From: Huff, Timothy A. <Tim.Huff@wsp.com>
Sent: Friday, May 19, 2023 10:03 AM
To: Rice, Caroline M - DNR
Cc: Ross, Issac A - DNR; Karl Beaster; Wesseldyke, Eric; Oman, Brandon J.
Subject: RE: SVE Design Report - Enbridge Line 13, Jefferson County
Attachments: Sheet 5 - 314V6019.705C-005 (Process and Instrumentation Diagram)-markup.pdf

Subject: SVE Design Report - Enbridge Line 13, Jefferson County

PROCESS AND INSTRUMENTATION DIAGRAM

LINE 13 MP 312 VALVE SITE
 FORT ATKINSON, WISCONSIN
 PREPARED FOR
 ENRGIDE ENERGY LIMITED PARTNERSHIP

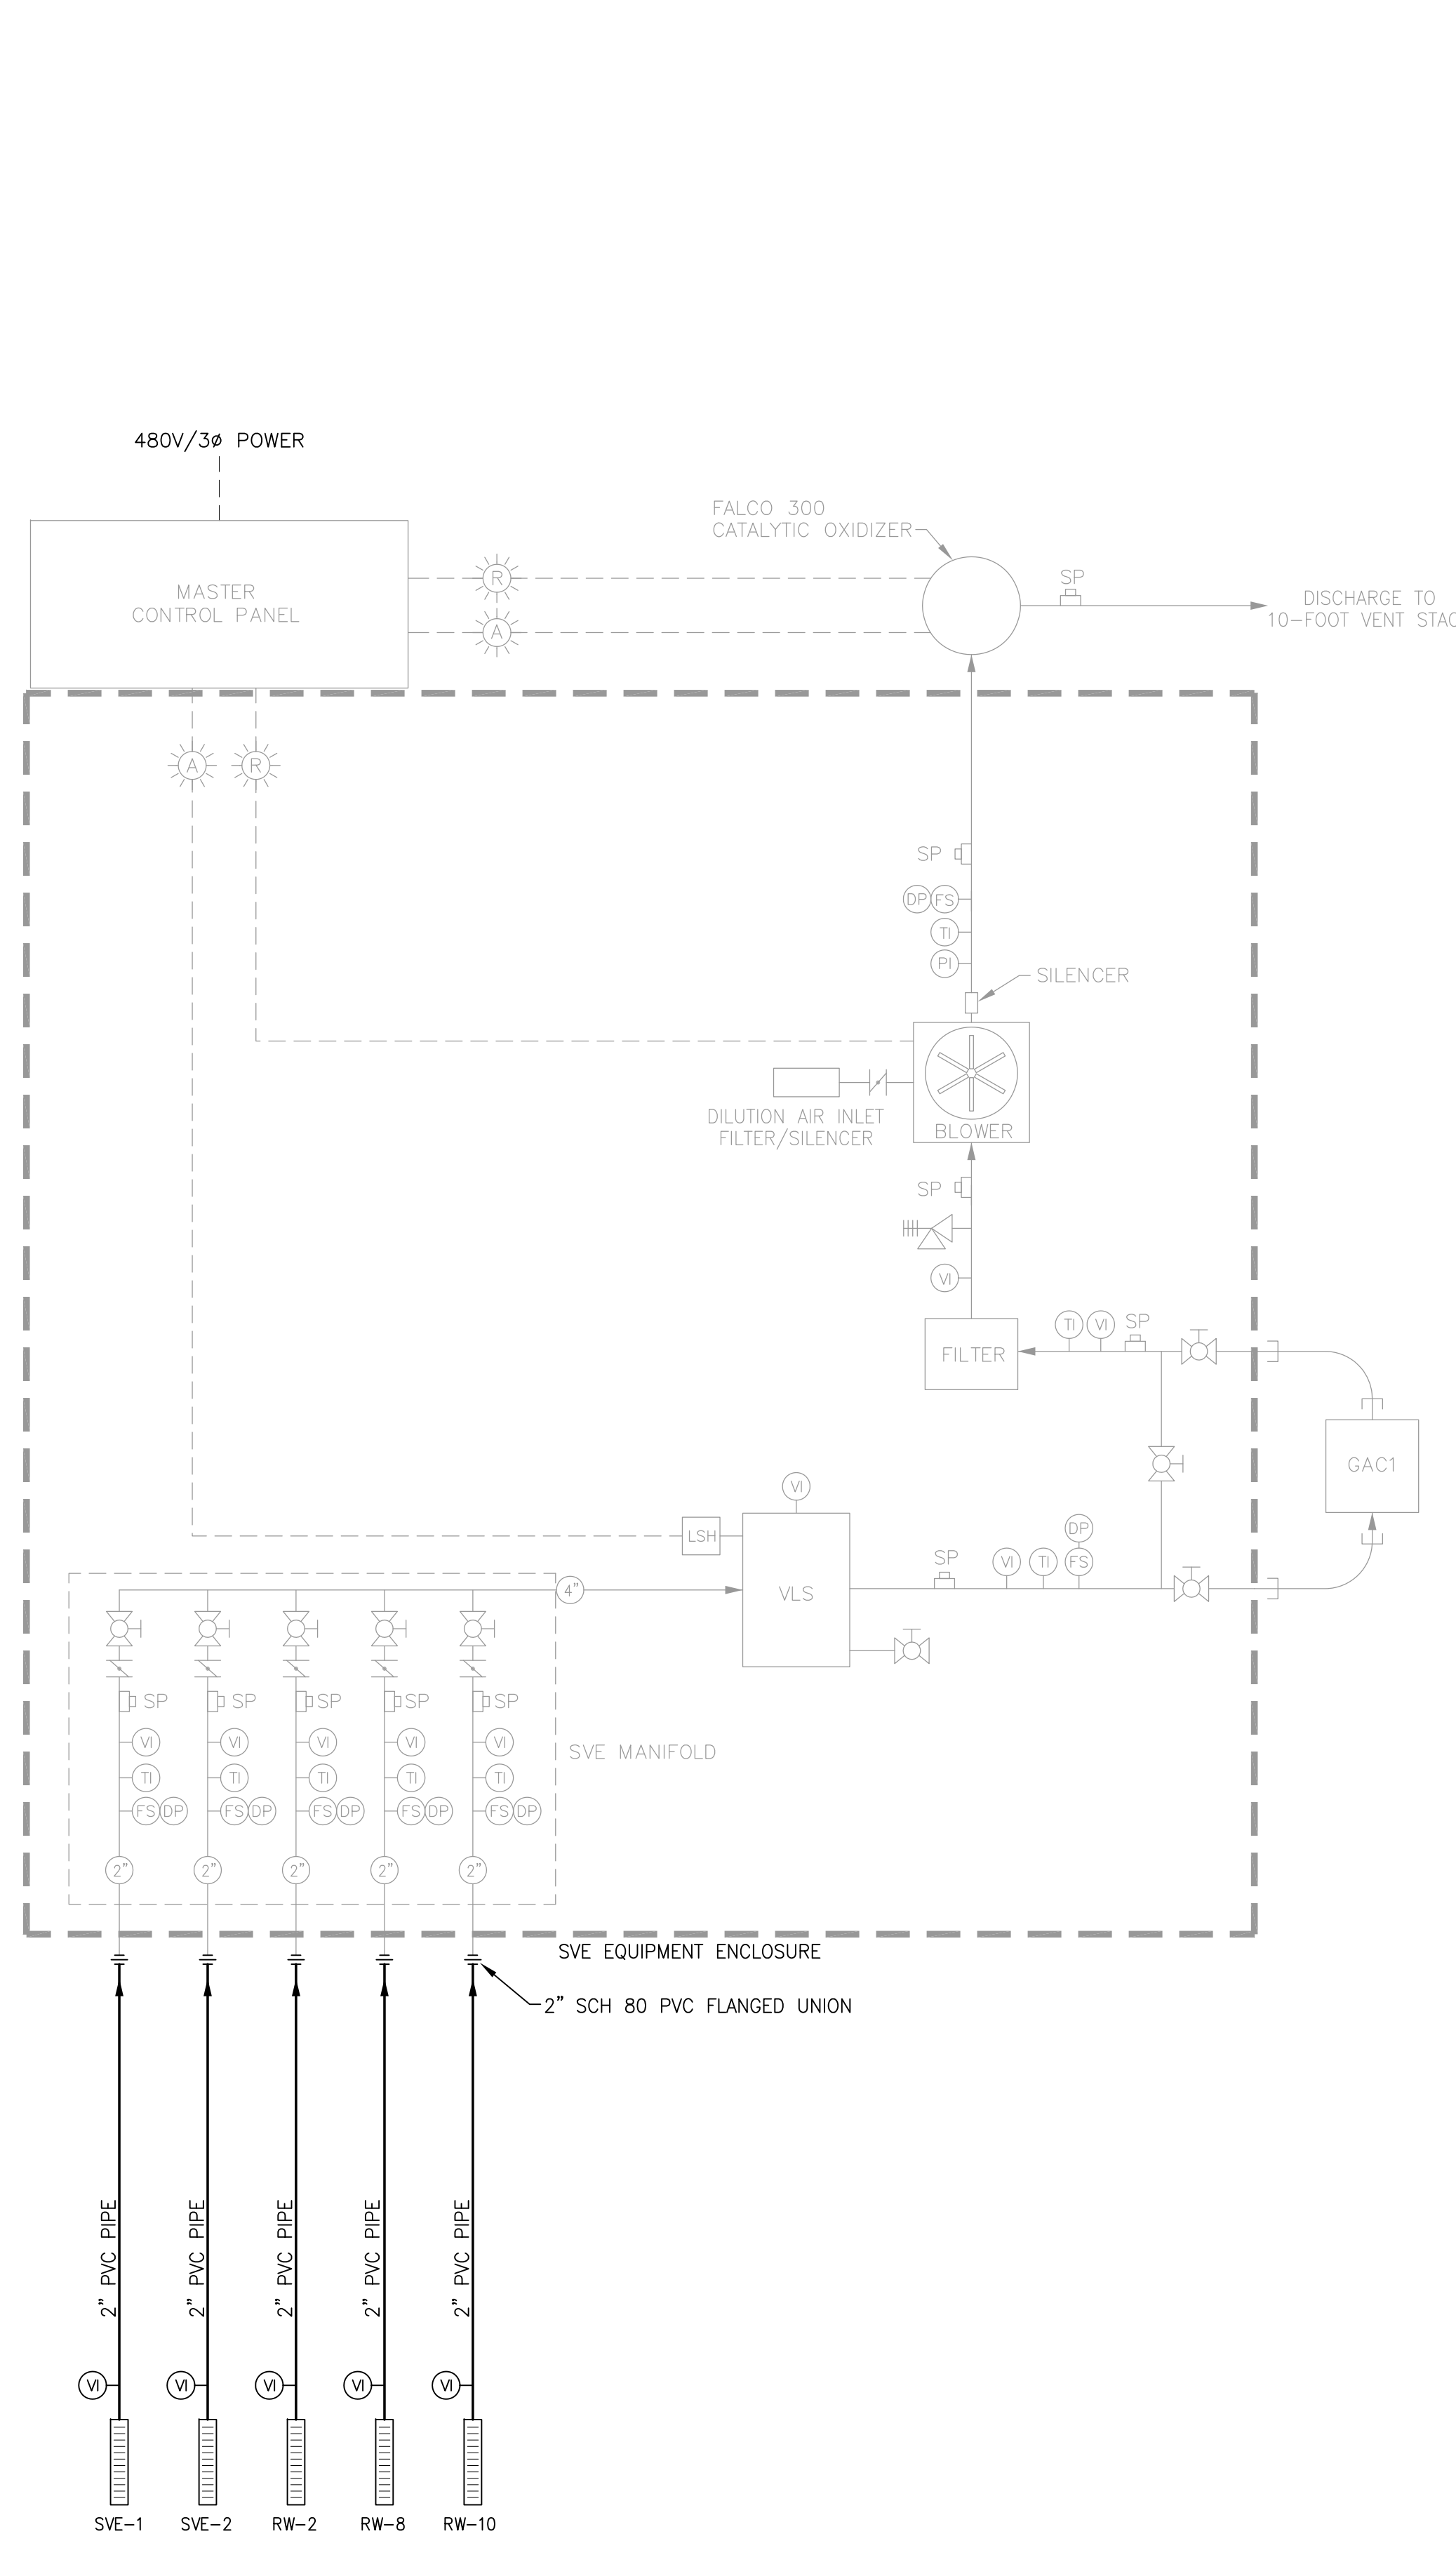
Thank you for submitting the SVE design report for DNR review. Please elaborate on how the vapor sampling described will provide sufficient data to calculate the mass of contaminant removed. We will need a reasonably accurate estimate of the mass removed to assess the effectiveness of the system and to determine if additional remedial actions will be required. Further, please confirm that pretreatment samples will be able to be collected after the system transitions to activated carbon treatment.

To elaborate on the method that was described in Section 6.1.2 of the SVE Design Report, WSP will collect vapor samples of the combined influent from the SVE wells upstream of any added dilution air for laboratory analysis of volatile organic compounds (VOCs) by EPA Method TO-15. The attached Sheet 5 from the SVE Design Report includes a comment to show where the combined influent sample will be collected. The combined influent sample point location will be upstream of the catalytic oxidizer in the startup treatment configuration and upstream of the granular activated carbon (GAC) vessel in the later treatment configuration. The concentration of individual VOCs in the air sample will be totaled to determine a combined influent total VOC concentration in the vapor extracted from the wells. The air flow rate of the combined influent from the SVE wells will also be measured upstream of the addition of any dilution air. The total concentration of VOCs will be multiplied by the air flow rate to get an estimated mass removal rate during a specified period of time. Finally, the mass removal rate will be multiplied by the number of blower motor runtime that has elapsed during that period of time to calculate the total mass removed. In order to regularly update the estimated mass removal rate, samples for laboratory analysis will be collected at least once per month, and the flow rate will be measured concurrently during each operation and maintenance (O&M) visit to the Site.

As mass is removed from the subsurface, it is anticipated that the rate of mass recovery will decrease over time. When the rate of mass recovery reaches asymptotic conditions, then verification soil sampling and/or LIF borings will be used to assess any residual soil impacts and verify the effectiveness of the SVE at reducing the concentrations of the contaminants of concern in the treatment area. The locations for the verification samples will be adjacent to the locations of soil samples or LIF borings from the 2021 supplemental site investigation work.
